Product Change Notification

Bourns® Model SDE0604A Series Non-Shielded Power Inductors

Winding Method Change and Manufacturing Process Improvement

IC1929

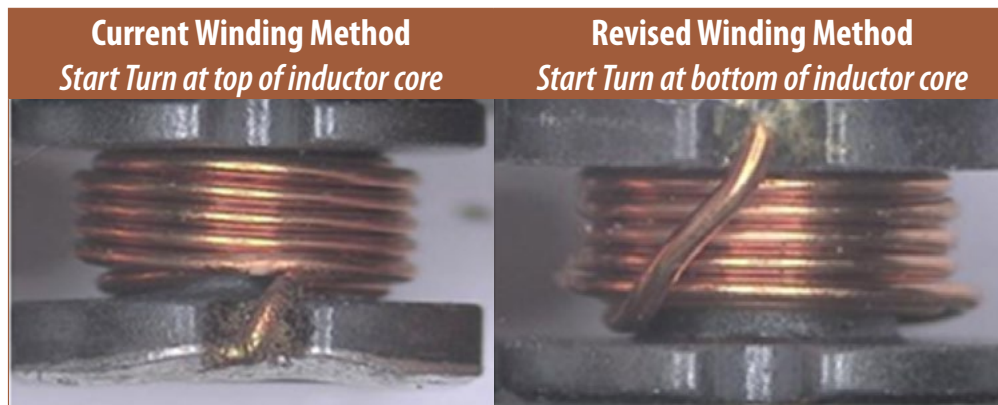
Bourns is making a change to the inductor winding process for the [Model SDE0604A](#). As a result of this change in the winding method, the form of the Model SDE0604A inductor will change.

The Starting Turn will begin at the top of the inductor core instead of from the bottom. This winding method helps to ensure that the wire insulation of the Start Turn will be impacted less by the soldering heat from the tinning process.
